**RIDEAU VALLEY CONSERVATION AUTHORITY  
Box 599, 3889 Rideau Valley Drive  
Manotick, Ontario, K4M 1A5  
(613) 692-3571, 1-800-267-3504**

**DRAFT MINUTES**

**Executive Committee Meeting Thursday, February 8, 2024 7:00 pm #2/24**

File Number: RV6-0622 and RV6-4723  
Date Received: January 22, 2024

1 SITE PLAN - DECK  
D5 SCALE: 1/4" = 1'-0"

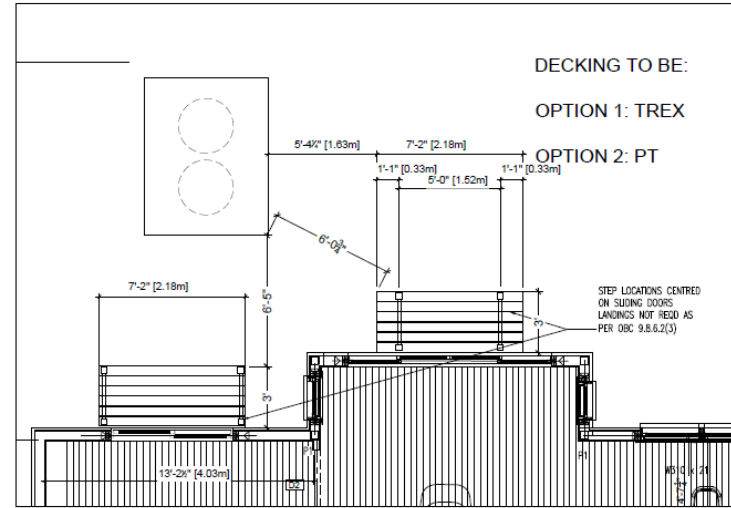
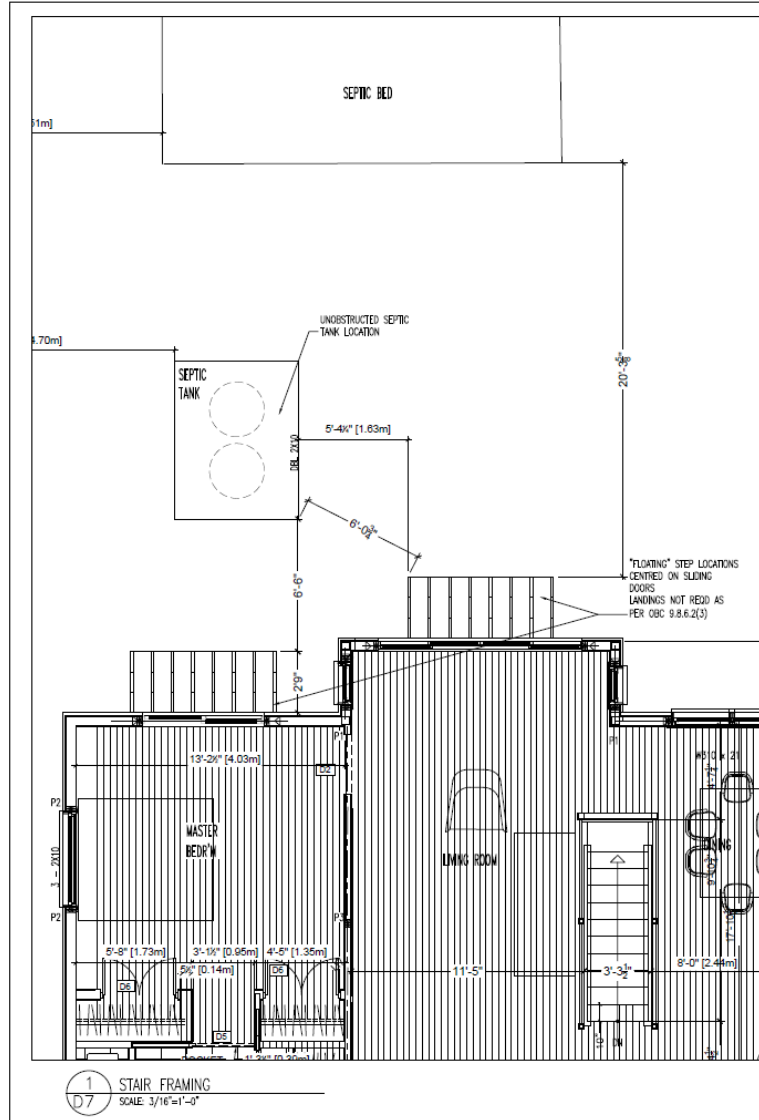
Construction of a covered porch. The wrap around porch roof was previously approved by the City as per stamped plans. Stamp date August 4, 2022. The porch decking follows the porch roofline to allow for use of the cover above. Without the porch decking, we are left with a sheltered area we cannot realistically make use of. We are retired and in our late sixties so it is very natural to desire to be able to enjoy the shelter provided by the porch roof. We picture sitting on it in the evening or morning to simply enjoy the rural nature of the setting. As such, we are submitting for a building permit to allow for use of this decking under such welcoming shade/shelter. It was advised however, that RVCA approval of this is required prior to the City providing building permit approval.

The approved plans limit the lower level height to 5'-11" as a result of the committee of adjustment decision file no. O38-02-21/A-00435. Current construction of the lower level appears to not be in conformance with the aforementioned. The height limitation on this space is explained by RVCA as intentional to limit the area as an unused crawl space to allow possible flood waters to pass through in and out of the crawl space through the foundation windows. We were told that because of this, all mechanical would need to be suspended under the floor above to prevent flood damage to it.

1 PORCH PLAN  
D10 SCALE: 3/16"=1'-0"

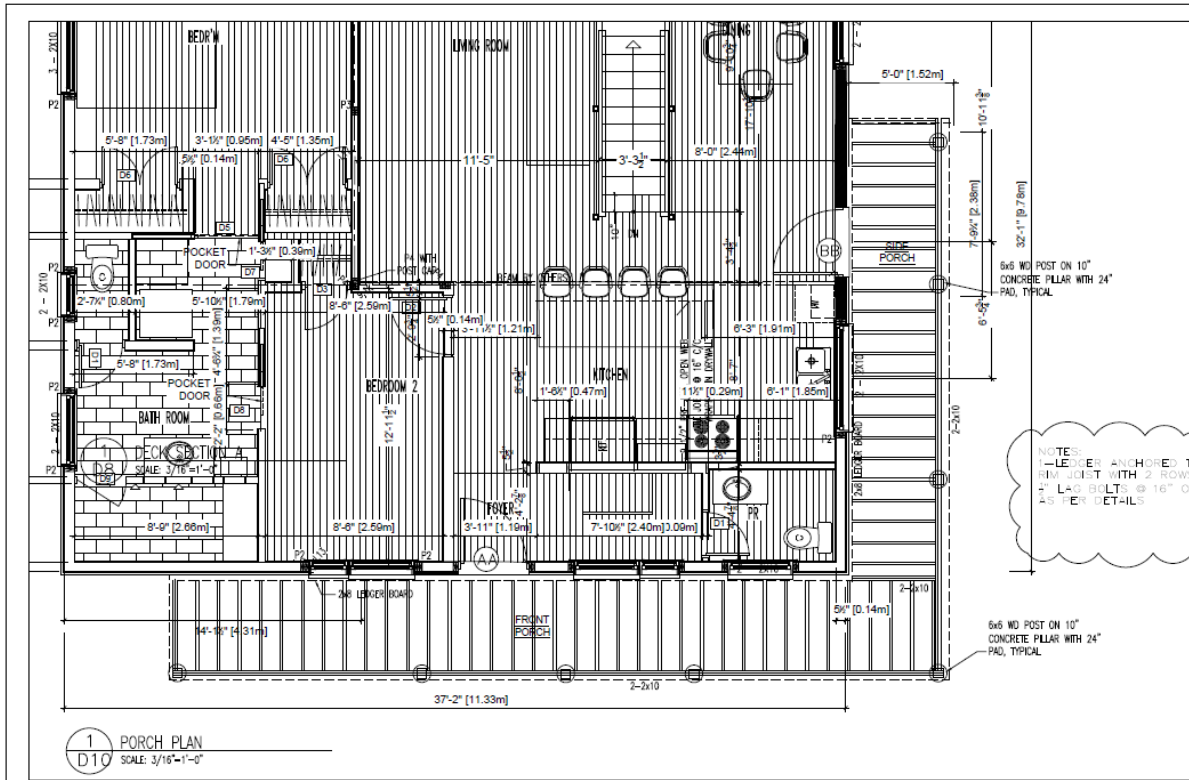
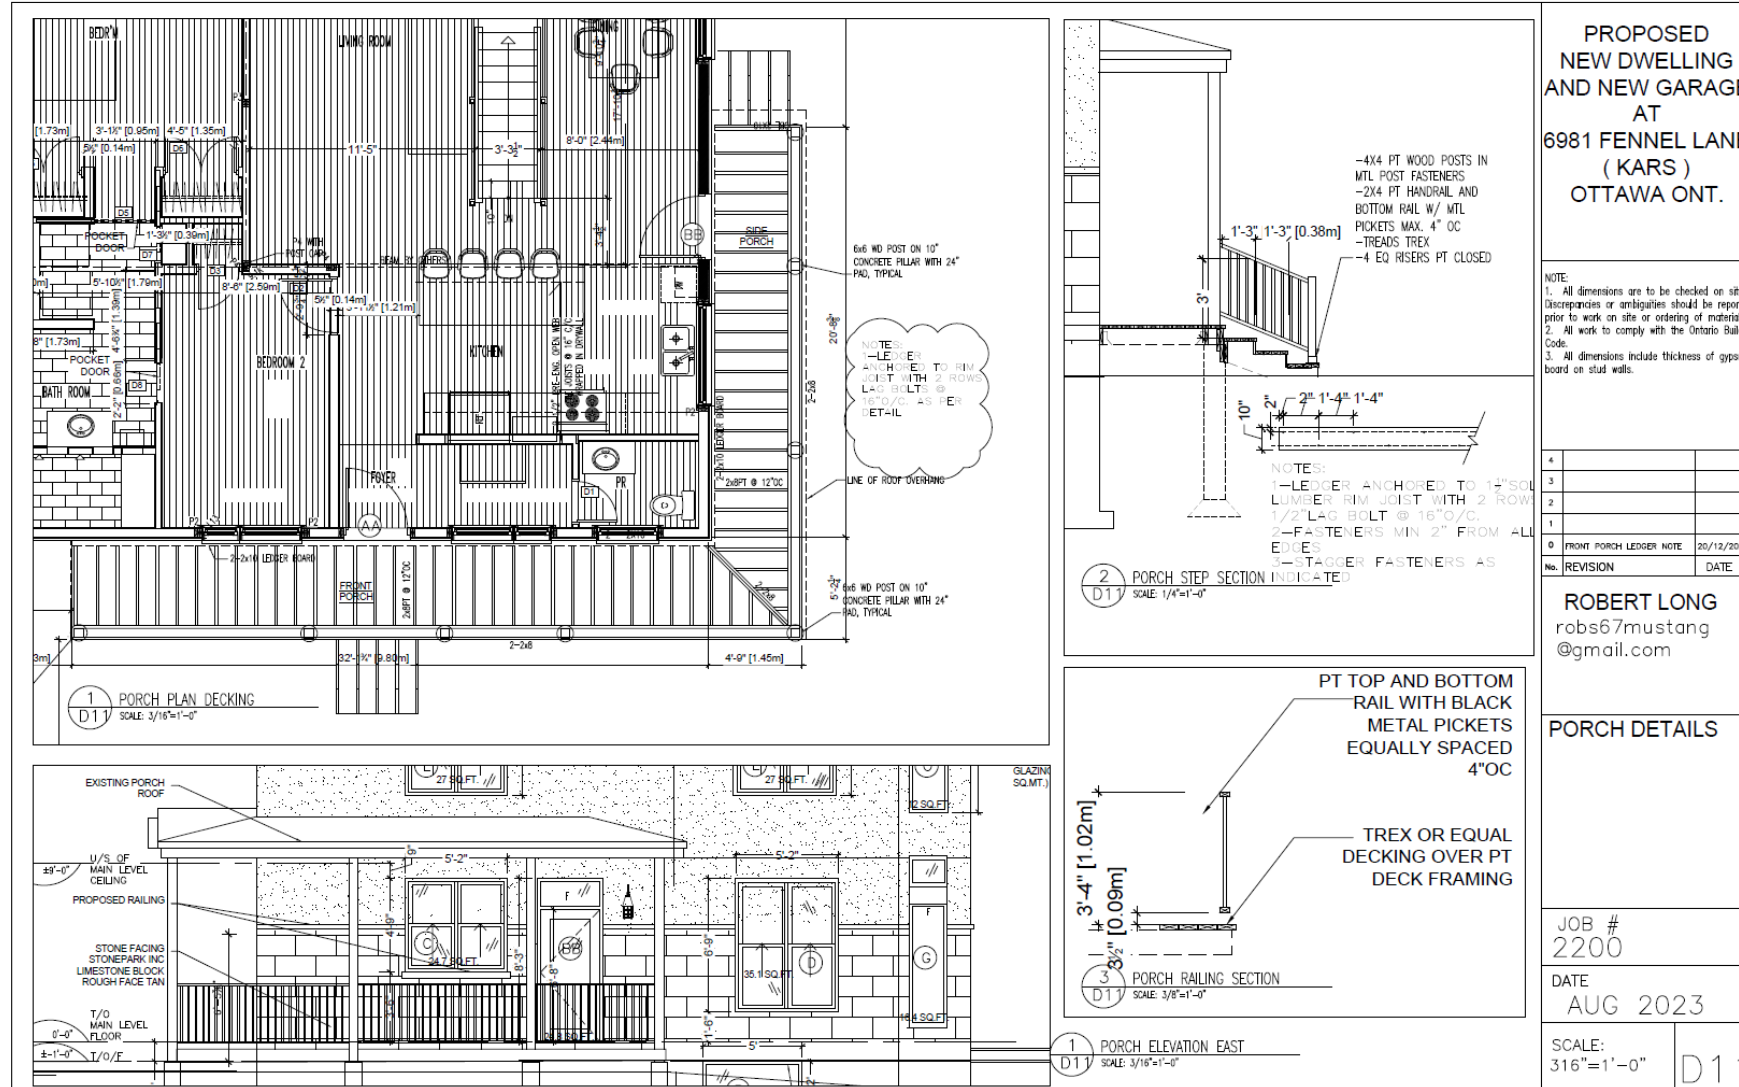
The slide depicts the proposed new dwelling and new garage at 6981 Fennel Lane, Kars, Ontario along with site photographs of the porch mid-construction. Mr. Lalande provided clarification on the originally approved plans for the porch, which entailed a small platform on one side of the dwelling without any cover. He highlighted unauthorized modifications that occurred during the development process, including the extension of the porch to connect each door and the construction of a porch cover, neither of which were included in the approved plans.

The slide depicts the proposed new dwelling and new garage at 6981 Fennel Lane, Kars, Ontario. The proposed plans include a wrap around, covered porch with metal rails.

1 BASEMENT SECTION  
SCALE: 3/16"=1'-0"

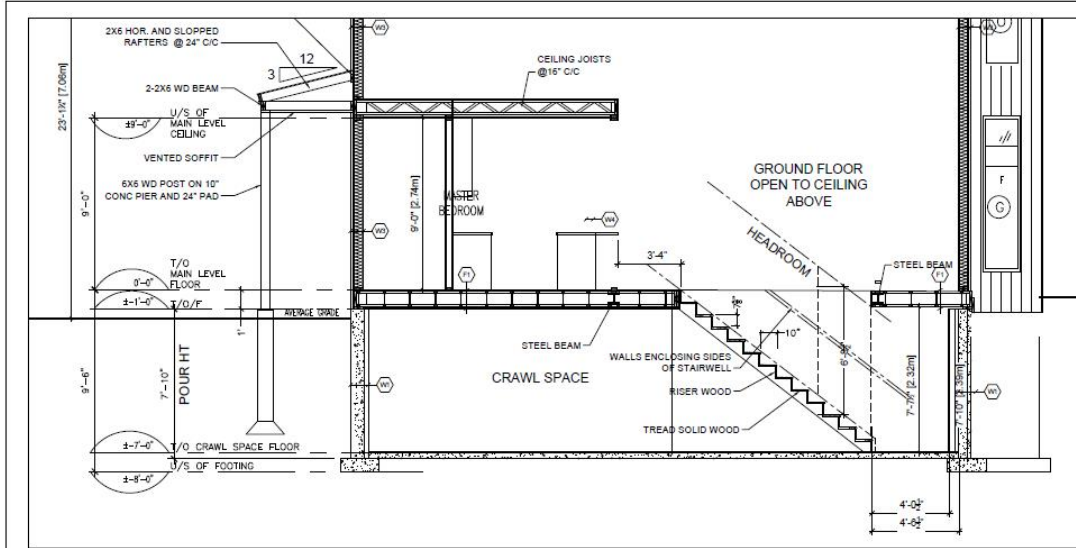
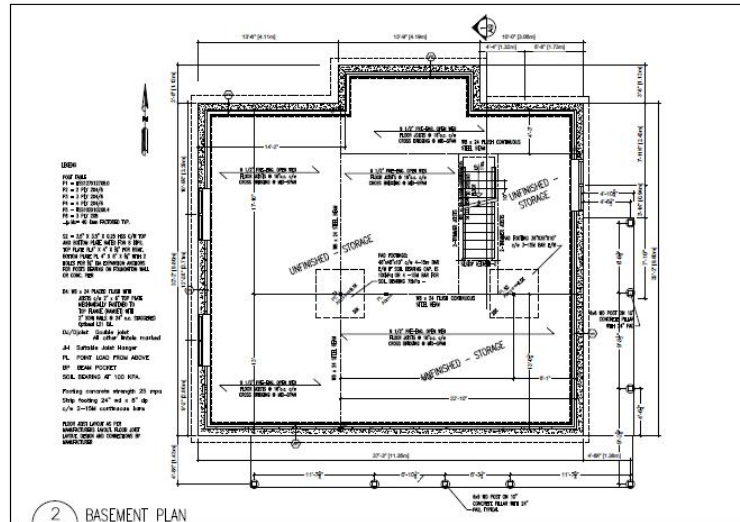
The slide depicts the proposed new dwelling and new garage at 6981 Fennel Lane, Kars, Ontario, and the inclusion of photographs of the crawlspace. Mr. Lalande underscored the disparity between the initial approved plans and the construction that has transpired. He specifically pointed out the alterations to the basement height and the installation of mechanical and electrical equipment.

There is insufficient information for RVCA staff to comment on floodproofing measures proposed by revised design. The current submission would be considered as wet floodproofed full height basement which is prohibited by policies.

Approved Grading Plan

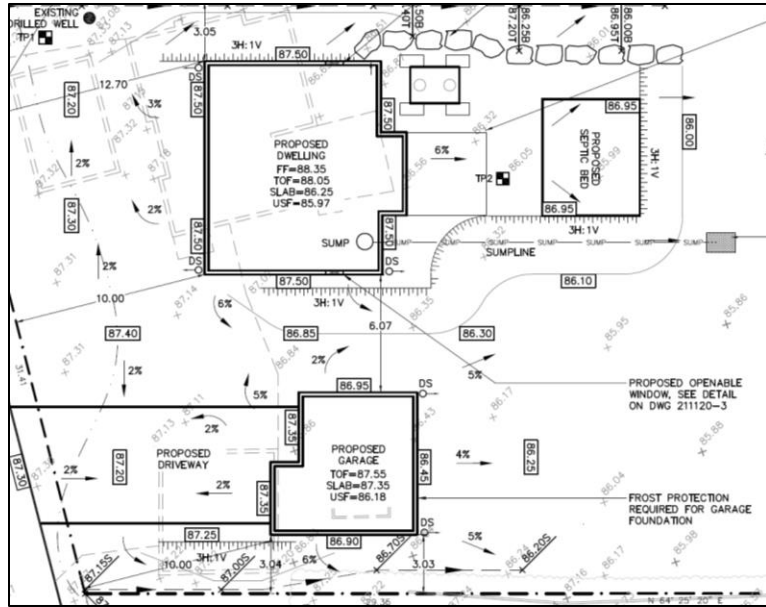
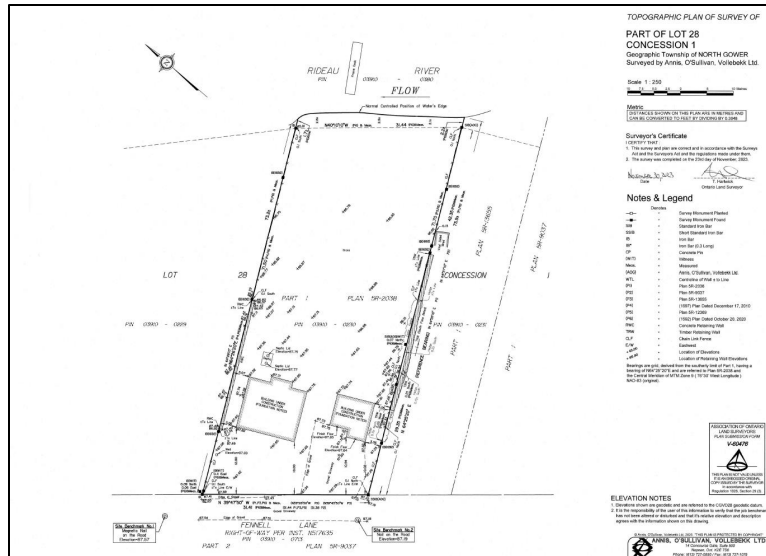
Mr. Lalande provided information regarding the approved fill plans in comparison to the ongoing construction work, highlighting discrepancies. He noted that an unquantified volume of fill has been placed on the property, surpassing the grading work approved by the original application. While the original grading plan was prepared by a qualified professional, the requested changes to the grading have not been presented or analyzed by RVCA policies.

Furthermore, the proposed fill does not account for any offsetting removal of fill and exceeds the depths outlined in the policies. Consequently, the policies cannot be met without significant alterations to the design, which may not be feasible given the proposed development's location within the floodplain. Therefore, it has not been demonstrated that the work requested as part of the revised application will result in no negative impacts on the floodplain.

# BASEMENT HEIGHT COMPARISON

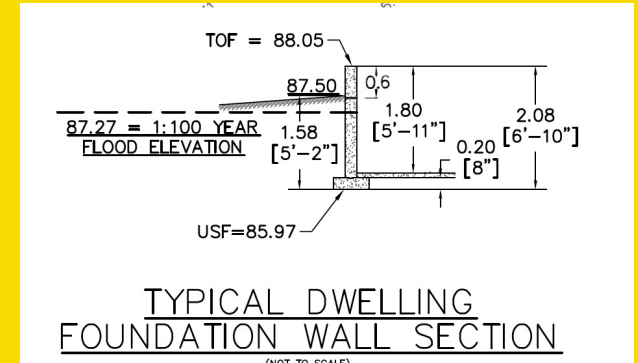
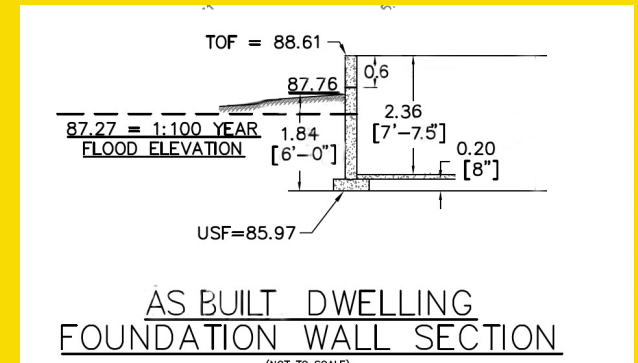
- Space will be used for storage purposes not living space
- Trapdoor floor hatch used to access lower storage area
- Basement storage will be suspended and/or raised system to avoid possible property damages and to allow for owner's access without bending or stooping
- Homeowners both aged late 60's
- Homeowners both with degenerative back conditions requiring good posture
- 5'-11" height limitation inhibits good posture resulting in pain

- Double sump pump installed with back up emergency generator
- Water alarm/sensor
- Bituminous foundation sealant
- Plastic foundation wrap membrane
- Wrap ties sealed with Bakor Aqua-Bloc

**ORIGINAL APPROVED GRADING PLAN**

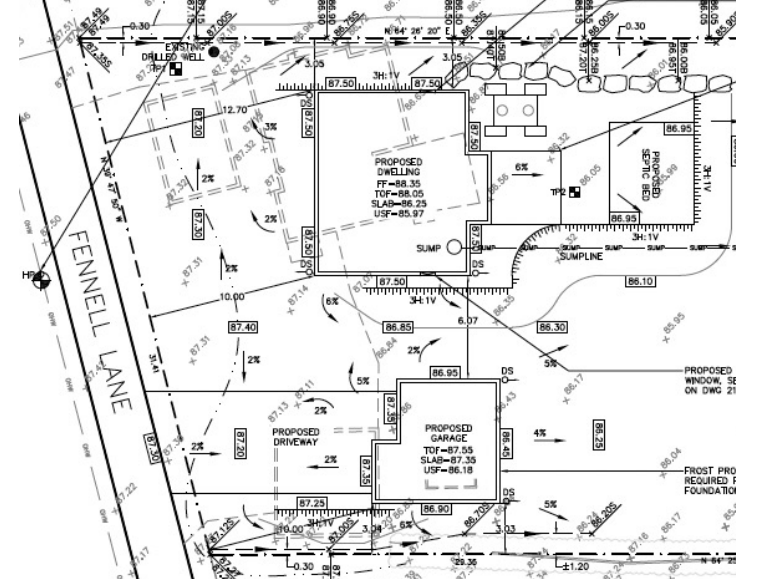
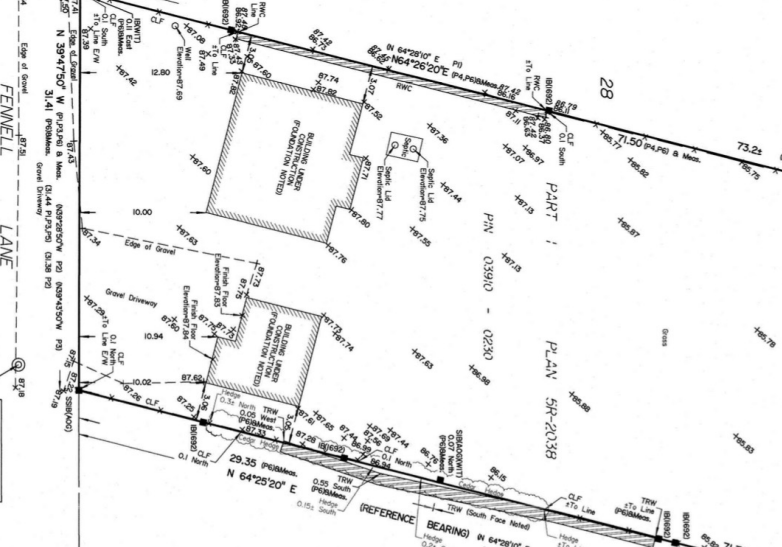
About the placement of fill, the presentation emphasized the necessity of a safe and gradual transition, contrasting it with the steep and irregular drop as seen on the original grading plan . Mr. Long highlighted that the fill on the property is not as extensive as that on neighbouring properties, and in fact, is slightly lower in elevation. He stressed that the as built grading plan had been approved by the City of Ottawa and is essential for facilitating the safe transportation of lawn care equipment. The gradual slope provided by the fill promotes accessible terrain and mitigates the risk of injury. Mr. Long sought approval to formalize the grade currently in place, referencing the as-built grading plan approved by the City of Ottawa on December 21, 2023. He provided further details, explaining that the fill does not extend as far towards the river as on the two abutting properties and complements the existing grading on adjacent properties. Moreover, he emphasized that the grading of the fill allows for a smooth transition to the lower yard, ensuring safe passage for property maintenance equipment and people. Mr. Long highlighted the importance of accessibility, particularly considering the advanced age of the owners, and noted that the grading prevents potential liability issues and visitor injuries that may have arisen with the irregular slopes shown on the original grading plan.

- as built grading plan approved by city of Ottawa Dec 21, 2023
- fill does not extend as far towards river as on two abutting properties
- fill complements the existing grading on adjacent property and is indeed somewhat lower in elevation than abutting properties
- grading of fill allows smooth transition to lower yard for safe passage of property maintenance equipment
- fill ensures accessibility considering owners advanced age eliminating steep and irregular slopes shown on original grading plan
- grading prevents possible liability and visitor injury issues that may have been encountered with irregular slopes shown on original grading plan
